Summary of your feedback on the Ash Street and Rata Street safety improvements

Auckland Transport (AT) is proposing a number of safety improvements along Ash Street and Rata Street in the suburbs of Avondale and New Lynn. We consulted on this proposal from 18 October to 14 November 2021 and received 141 submissions.

Support for the proposed changes to the Great North Road, Rata Street and Titirangi Road intersection

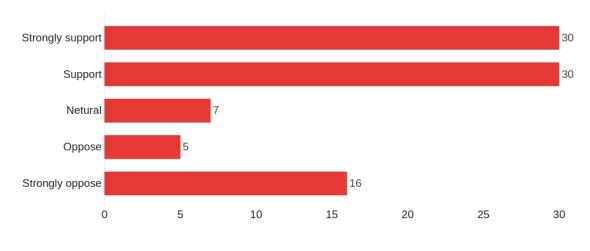
This question received 61 comments. The overall top theme in the feedback is strongly oppose the proposed changes to the Great North Road, Rata Street and Titirangi Road intersection. A total of 56.52% of people either opposed or strongly opposed the proposed changes, while 38.1% of people either strongly supported or supported the proposed changes.

The three main reasons given for opposing the safety improvements to the intersection where increased congestion (19.7%), impacts on vehicle speeds (17.4%), and speed tables (12.1%).

"Do not make that intersection even worse with causing more traffic congestion and delays due to the reduced amount of cars going thru the lights"

"This is a major arterial route where the traffic needs to flow"

"Slowing down traffic at the same time as volume is increasing will lead to greater backlogs affecting even more streets/suburbs"

A number of submitters commented that the impact that the changes to the intersection would reduce vehicle speeds. While most of the comments did not support the safety measures because they may reduce speeds, there were others who welcomed a reduction in vehicle speeds.

"Can't legislate for idiots- if you're not speeding and paying attention ie not texting on the phone there shouldn't be a problem"

"The proposed change will dramatically reduce the traffic handling capability and decrease the energy efficiency of vehicles by forcing them to slow to an unrealistic speed regardless of the prevailing conditions."

"The speed limit should be reduced to no more than 30km/h"

"There should be no slip lanes. they increase speeding and deaths"

"the green cycle patch on the right before the lights on rata street (when waiting to turn right into grt nth rd)... that green patch should surely go in the middle lane (the lefthand of the right turning lanes)."

"Safe separated cycle lanes are missing, please add these."

"It is essential to add protected bike lanes now."

"There is currently no safe cycling infrastructure along rata street to great north rd. I ride home everyday along this via waterview"

Support for adding a refuge crossing island on Rata Street, near Caspian Close

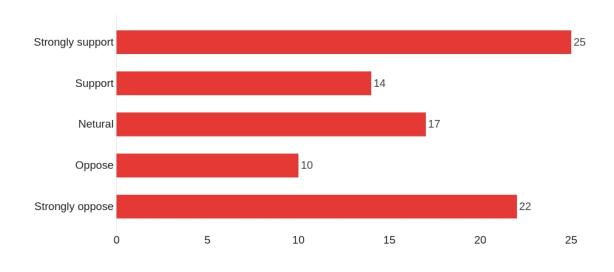
This question received 42 comments. The main focused of the comments were on the pedestrian refuge and crossing (41.2%).

"This solution seems like a safe access point for pedestrians whilst not hindering traffic."

"I suggest and over crossing pedestrian bridge."

"There are traffic lights that support foot traffic about 100m away from this proposed crossing? Why make turning into rimu street harder than it is?"

"In principle I support pedestrian refuges, but I question this particular one for two reasons. It is in close proximity to the proposed pedestrian traffic lights at 56 Rata St and the traffic lights at the Rimu St intersection so the majority of pedestrians will have already passed one of those on their way to Caspian Close. Secondly it will limit the queueing capacity for vehicles turning right at Rimu St."

The safety and design of the refuge was also raised by some people (8.8%).

"Terrible design. This is totally unsafe. For a 4-lane road, this needs a controlled raised zebra crossing."

"It's need to be safe as the residents that live in that area and also kids and elderly to cross over safely."

"I strongly agree with putting pedestrian crossings. This will ensure pedestrians safety."

Support for a traffic light controlled crossing being installed near 56 Rata Street

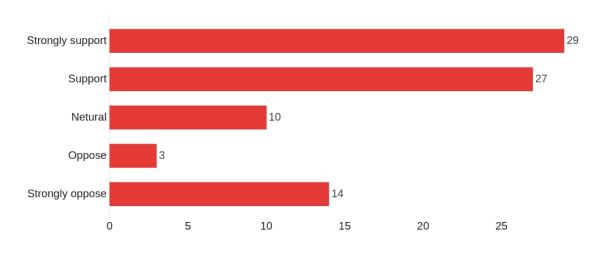
This question received 41 comments. Comments relating to reduced vehicle speeds and congestion were the most common theme from submitters (28.1%):

"Traffic flow is super important. It's already congested in this area."

"More just blocking the flow of traffic for no reason."

"Traffic flow is the lowest priority, safety is top priority."

"No, this whole road gets hit with traffic especially in the mornings as it is. This will just create more traffic. The bit of road before the Great North Road on ramp that has 3-4 lights on it is the worst because of the lights. Adding more lights to these roads is the worst for creating traffic."

"A pedestrian refuge would have been preferable but there is no median strip to locate it in."

"This isn't safe. It needs to be a controlled raised zebra crossing. Traffic flow is the lowest priority, safety is top priority."

"Traffic lights will ensure cars stop for pedestrians"

"Crossing are needed, but you will need to evaluate if that is the correct spot after a curve of high speed traffic"

Support for adding a refuge crossing island near 75 Ash Street

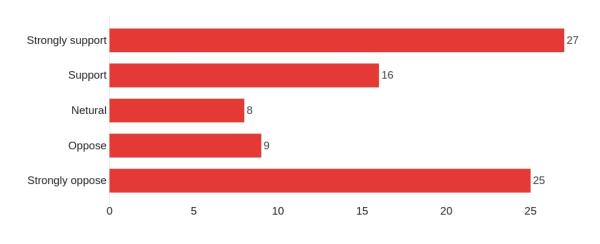
This question received 31 comments. A third of submitters mentioned the pedestrian refuge and crossing.

"Yet again, must be a controlled raised zebra crossing."

"Traffic lights not very far away. Encourage people to use them instead of jaywalking"

"I have never seen anyone crossing at or around 75 ash street, except Sundays for the markets and they just cross anywhere, they don't even use the crossing provided."

"A refuge crossing implies this is a place to cross the road. This will encourage more people to cross here not less."

"Traffic lights not very far away. Encourage people to use them instead of jaywalking"

"People should walk to the nearest traffic lights"

So many traffic lights and pedestrian lights."

"If your going to put in a medium strip, you effectively narrow the road, you need to have no parking on the side of the road as the second lane will become redundant."

"Please remove all on-street parking from Ash street, including weekends."

"Instead, you build like for like renewals or, as here, you tinker around the edges while preserving throughput and parking for cars."

Support for the proposed changes to the intersection of Wairau Avenue and Ash Street

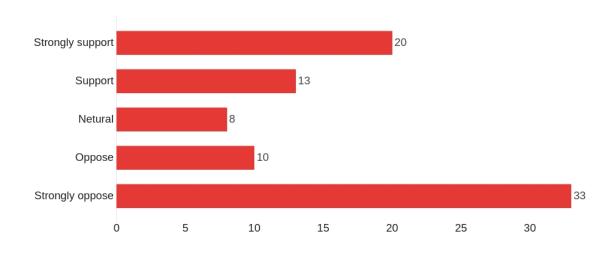
While there was support for signalising the Wairau/Ash intersection, many of the comments were opposed to the move, especially the addition of any speed tables. There were 18 comments associated with speed tables.

"WE DO NOT NEED SPEED BUMPS AT A TRAFFIC LIGHT"

"Humps again in my opinion are dangerous and will detrimentally affect traffic flow whilst lights are on green."

"Raised table is unnecessary and annoying to motorist."

"Yes to traffic lights but NO to the raised humps."

"No speed bumps on Ash st, put them in wairau only"

"Raised tables damage vehicles and cause discomfort for drivers and passengers otherwise I like this idea"

"NO more traffic lights, send them up Canal Rd to Rosebank Rd"

"This will put two sets of traffic lights in a very small piece of road as there is already one set by the petrol station."

"A traffic light directed right turn would also stop all the idiots who try to turn right without at least driving to the racecourse to do u-turn causing heaps of near misses."

"Leave the intersection no right turn"

"Also the speed bump in this picture would be hazardous to cyclists because there is a drop into the gutter that a cyclist could risk slipping into and coming off the bike and under a car/truck"

"Missing those safe separated cycle lanes."

"It is vital to prioritise the safest and most efficient modes, which is walking and cycling"

"All of your plans and policies mandate proper provision and protection for walking and cycling, but time and time again you fail to provide it ... It is a key link in the cycle network that you know you should be building."

"But no safety improvements for people on bikes"

Support for the proposed changes to the Rosebank and Ash intersection

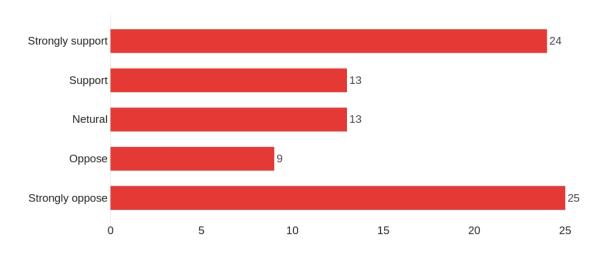
The main opposition to the proposed safety improvements was the introduction of speed tables to the Rosebank/Ash intersection (17 mentions).

"I do not support speed tables on Great North road"

"It's not a great idea to put speed humps here, but it makes far more sense how you have put them a little bit further back from the intersection rather than trying to do everything at the intersection itself (like the rata street/ great north rd proposal which is dangerous for cyclists and inappropriate)."

"Speed bumps will just create massive congestion in rush hour"

"Unnecessary, maybe it's better to enforce the law in these areas rather than unnecessary speed changes due to bad drivers"

"Cars and trucks are are doing 100k at times, the noise affects peoples lives, the trucks bounce on the road abd crash back down."

"this wil result in drivers speeding up to get though the lights after the speed humps that have slowed them resulting in more nose to tail accidents."

"Have you even considered ways of getting the traffic to more???>"

"Speed bumps will just create massive congestion in rush hour"

"an added note about the rata street one is that coming downhill on great north rd and turning left onto rata would be far more dangerous on a bike if there were speed bumps there!"
